Informal document No. GRSG-93-24
(93rd GRSG, 23-26 October 2007,
Agenda item 13 (a))

Draft corrigendum proposal to the draft gtr concerning safety glazing materials for motor vehicles

Transmitted by the Informal GRSG Safety Glazing GTR Working Group

Figure 2 Head-form

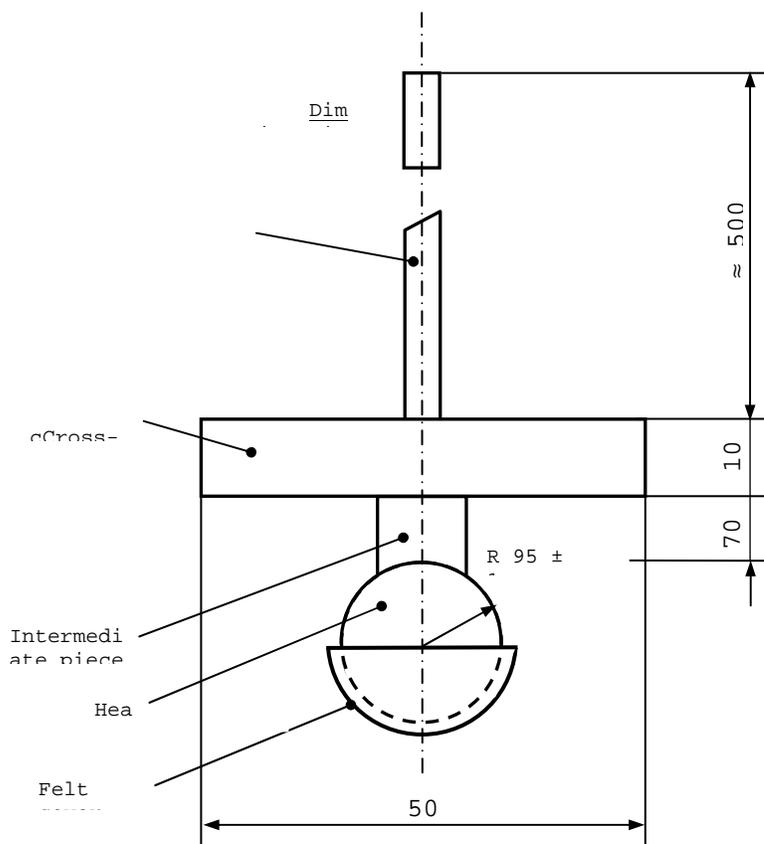
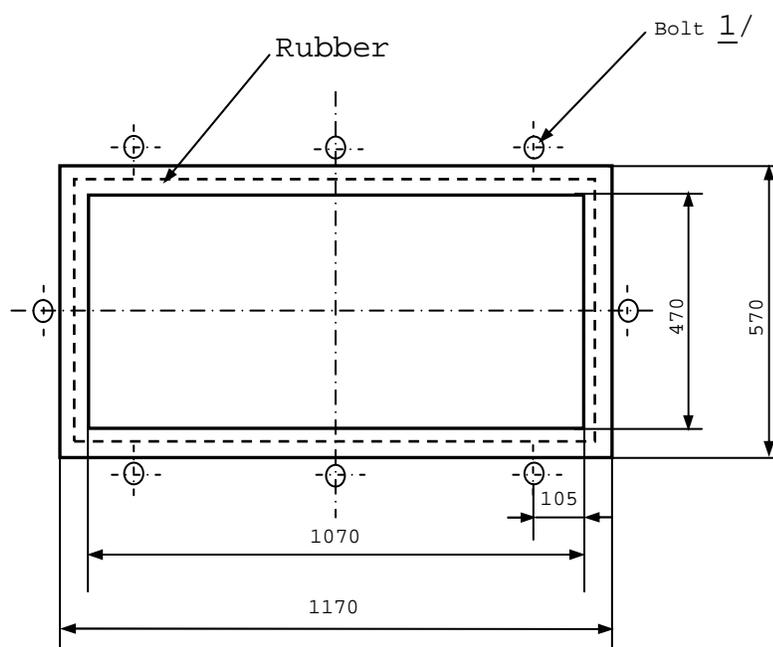
Paragraphs 6.5. to 6.5.5.2., amend to read the paragraphs in []:

6.5.1.1.2. The dimensions shall be in accordance with Figure 2.

6.5.1.1.1. Spherical or semi-spherical head-form made of laminated hardwood covered with replaceable felt and with or without a crossbeam made of wood. There is a neck-shaped intermediate piece between the spherical part and the crossbeam and a mounting rod on the other side of the rod on the other side of the crossbeam.

6.5.1.1.3. The total mass of the head-form shall be 10 ± 0.2 kg.

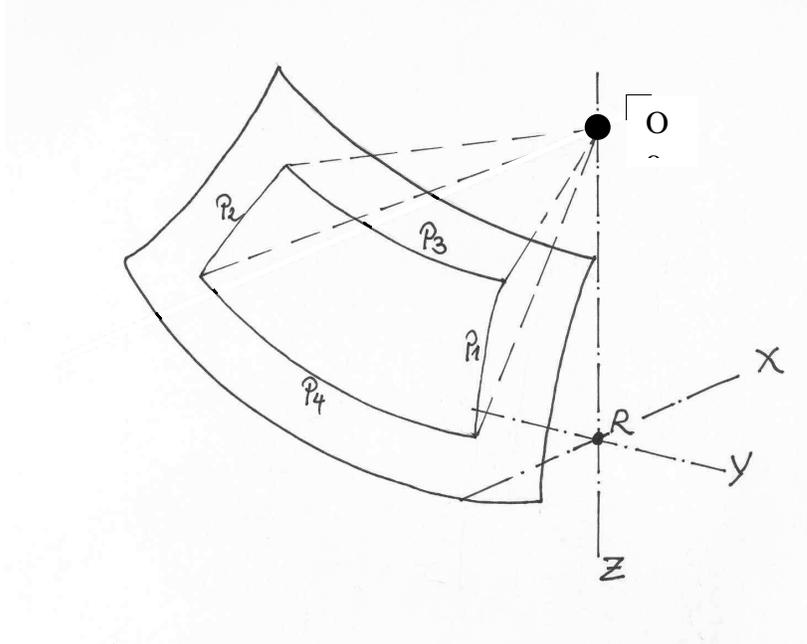
Paragraph 7.1.3.3.2., amend 5th and 6th paragraphs, to read:

P3 a plane passing through a **transverse horizontal** ~~straight~~ line containing O ~~QQ~~ and forming an angle of 10° above the horizontal plane;

P4 a plane passing through a **transverse horizontal** ~~straight~~ line containing O ~~QQ~~ and forming an angle of 8° below the horizontal plane;
